MOD2024/0252

S4.56 SUMMARY OF CHANGES:

Project Name
1955 Pittwater Rd., Bayview

Drawing Title
Site Plan

Drawing no:
DA.101

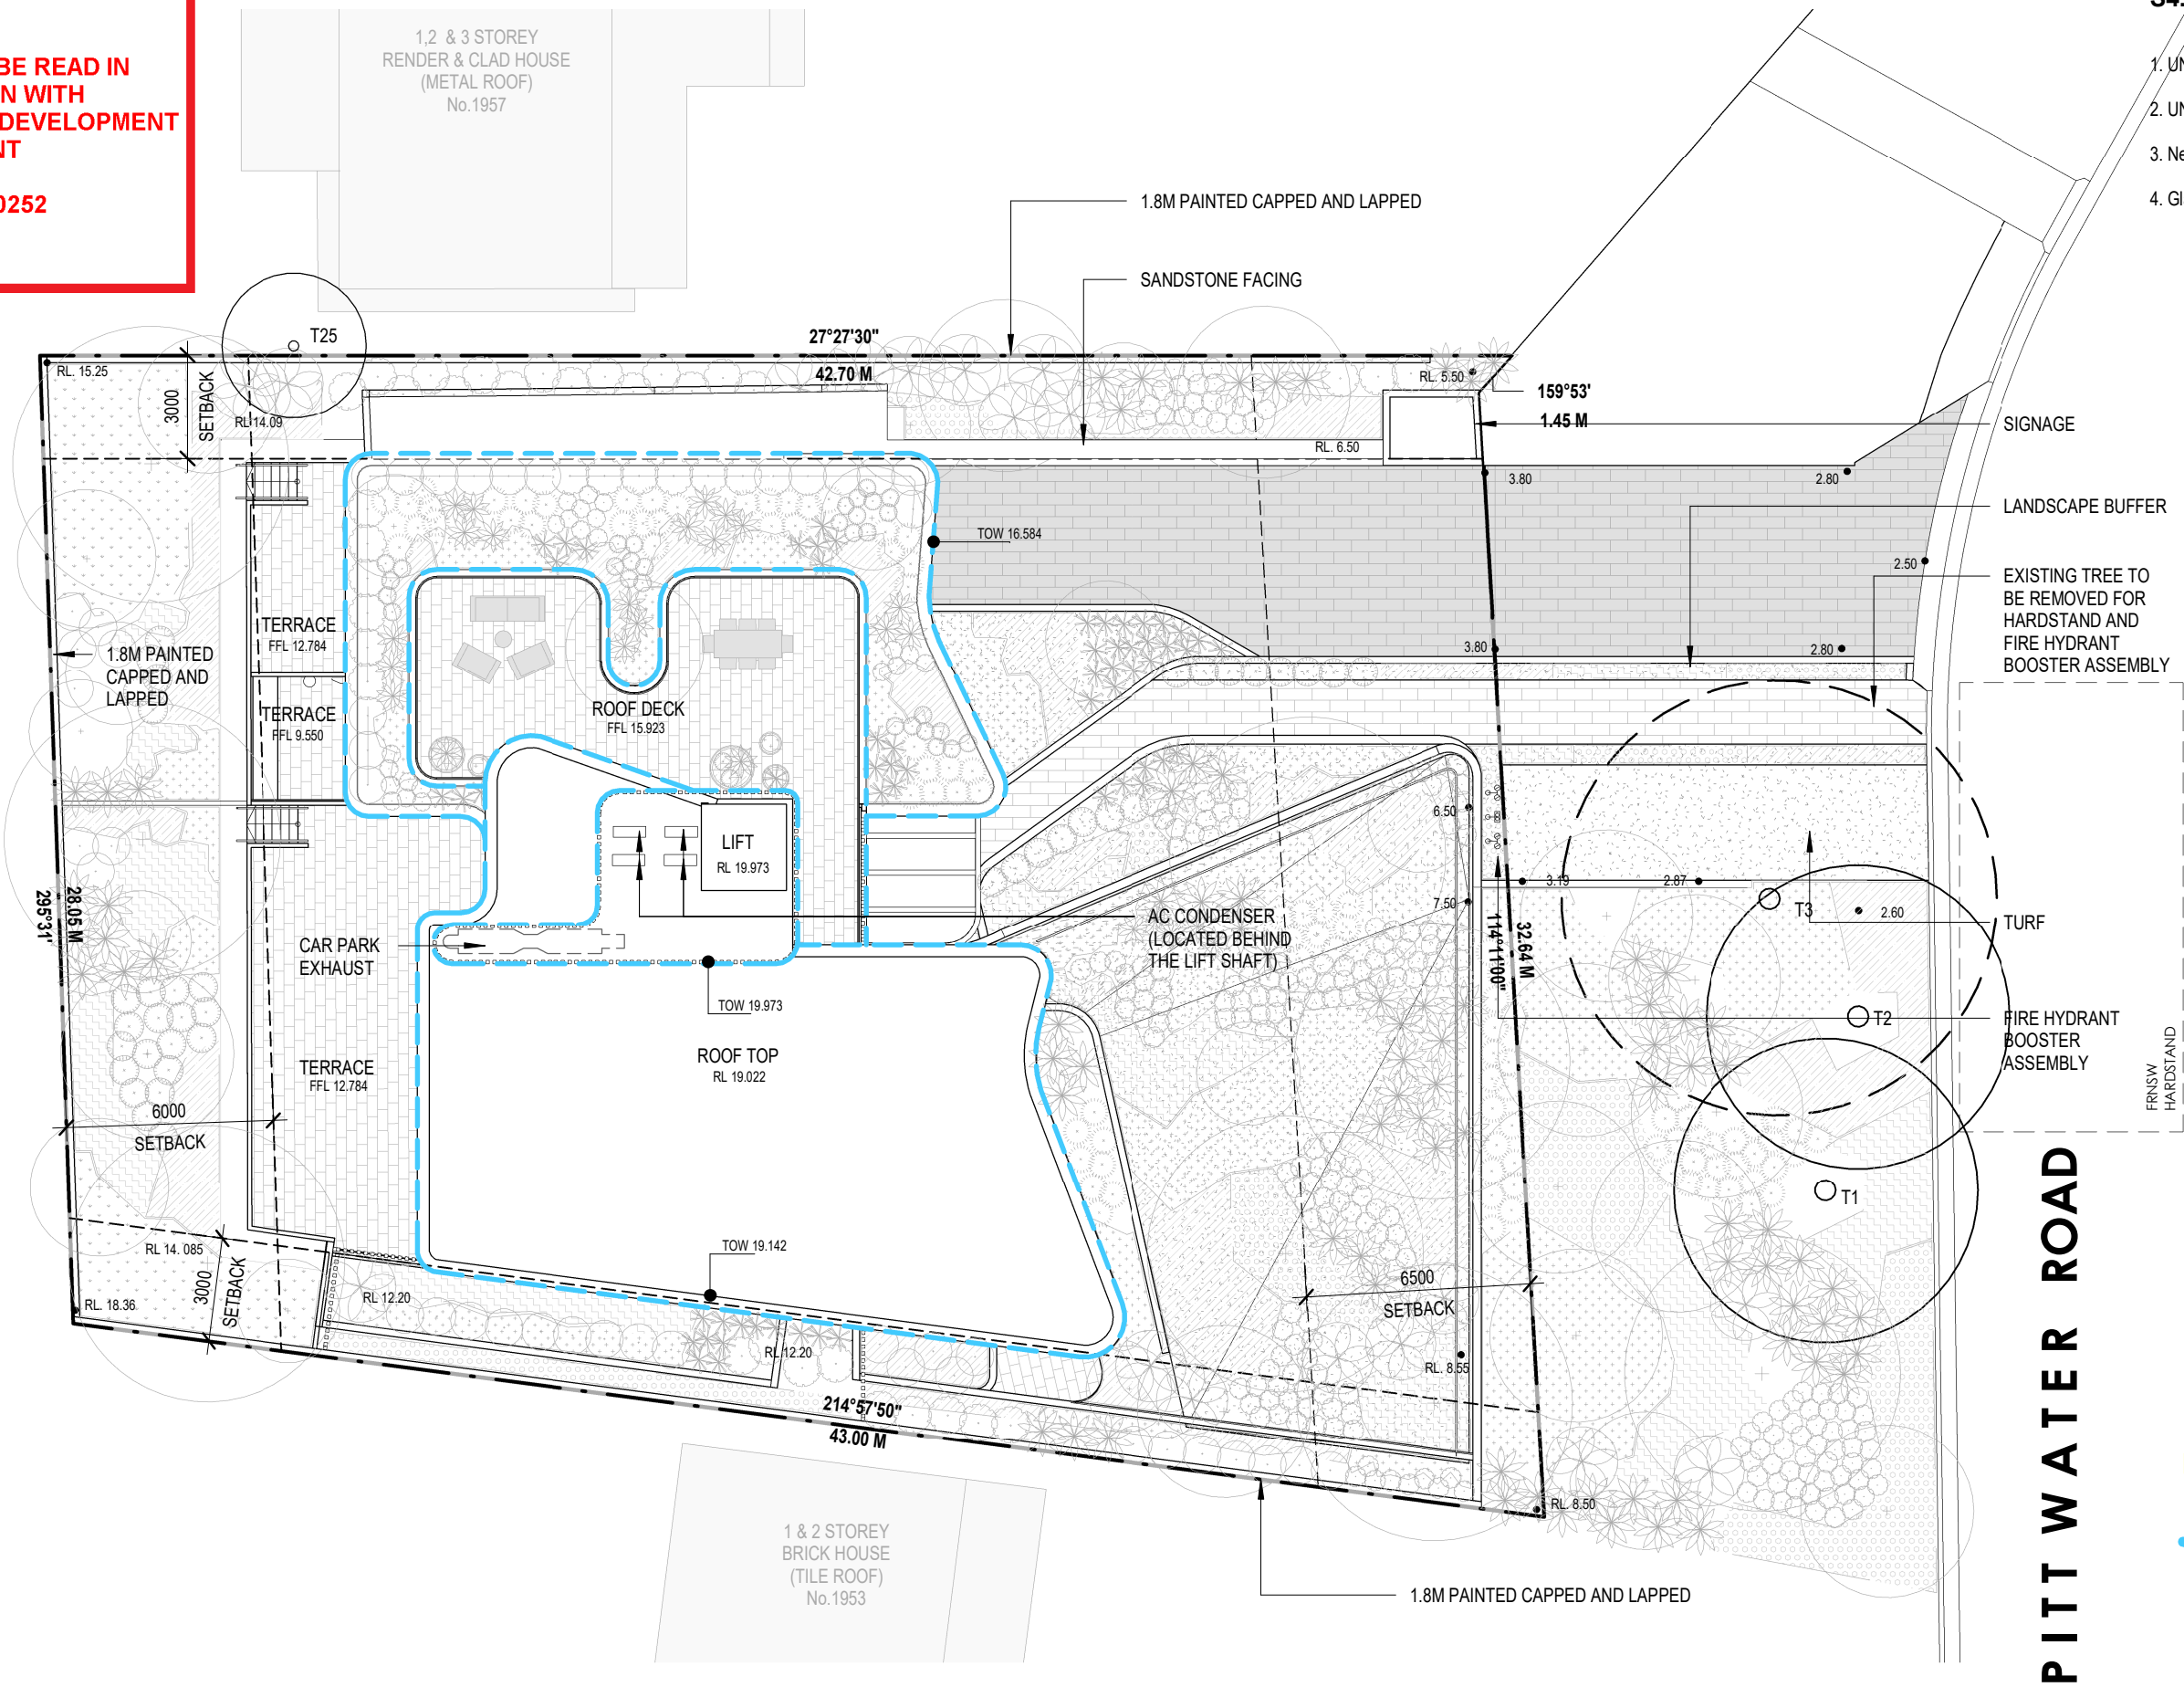
1. UNIT 1 layout re-configuration to improve amenity
2. UNIT 4 relocation of Laundry Room
3. New window to provide ventilation
4. Glazing adjustment for better alignment

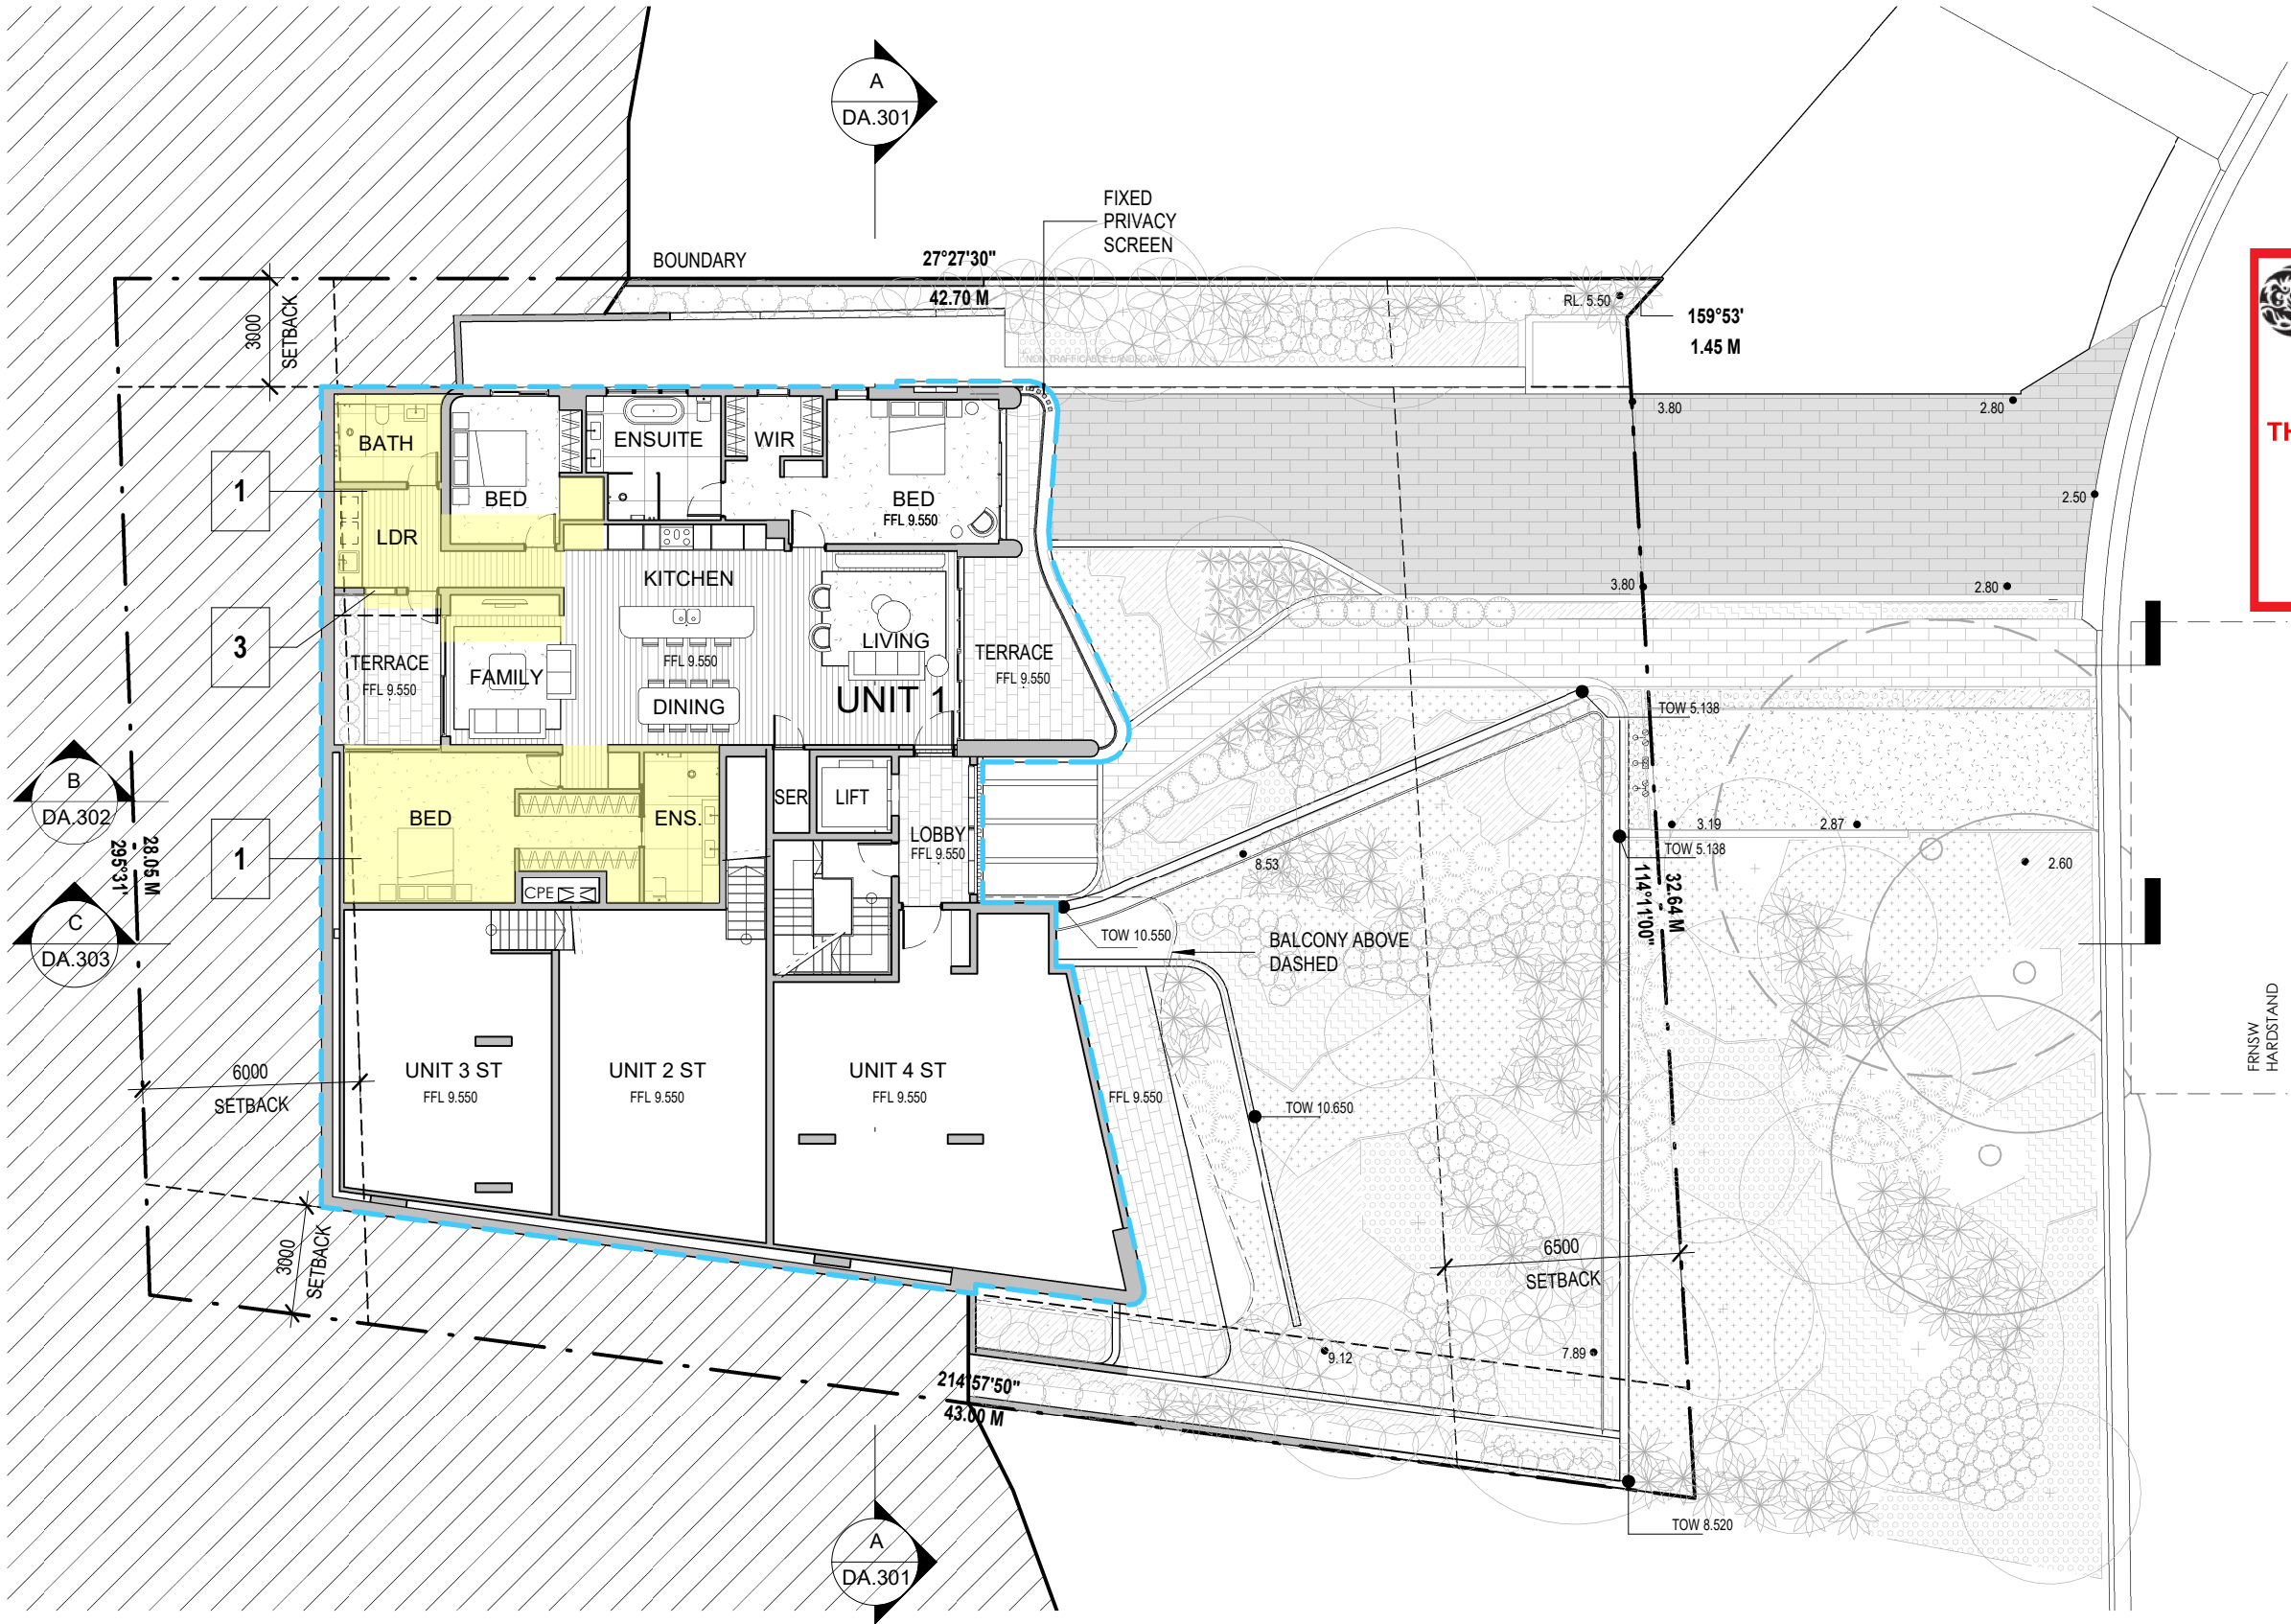
S4.56 SUMMARY OF CHANGES:

- 1. UNIT 1 layout re-configuration to improve amenity
- 2. UNIT 4 relocation of Laundry Room
- 3. New window to provide ventilation
- 4. Glazing adjustment for better alignment

Drawing no:
DA.204

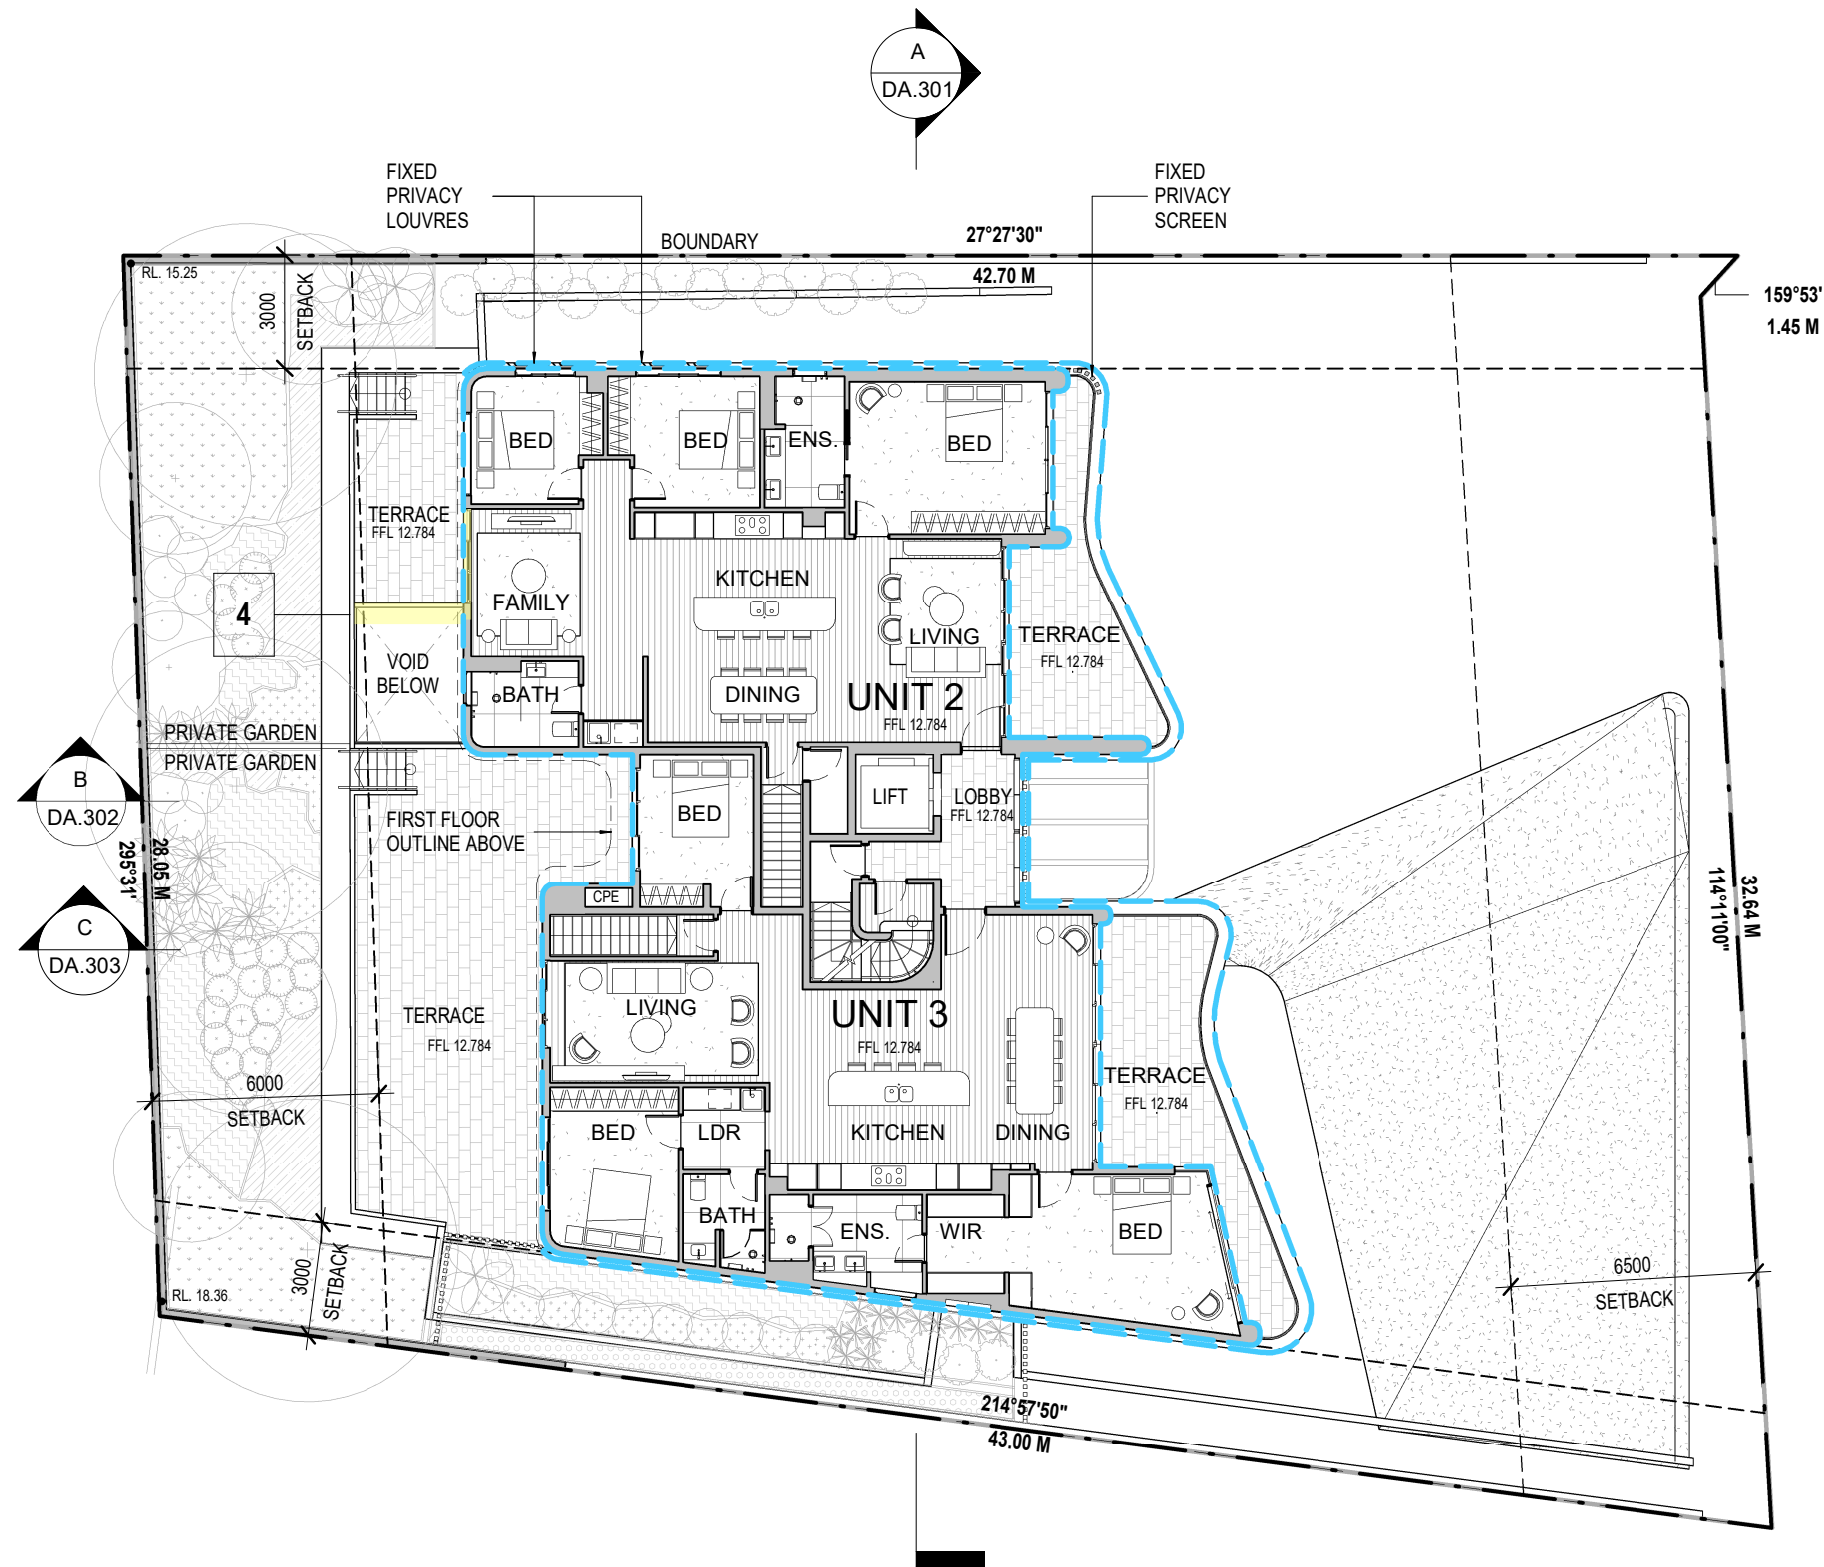
- 1. UNIT 1 layout re-configuration to improve amenity
- 2. UNIT 4 relocation of Laundry Room
- 3. New window to provide ventilation
- 4. Glazing adjustment for better alignment
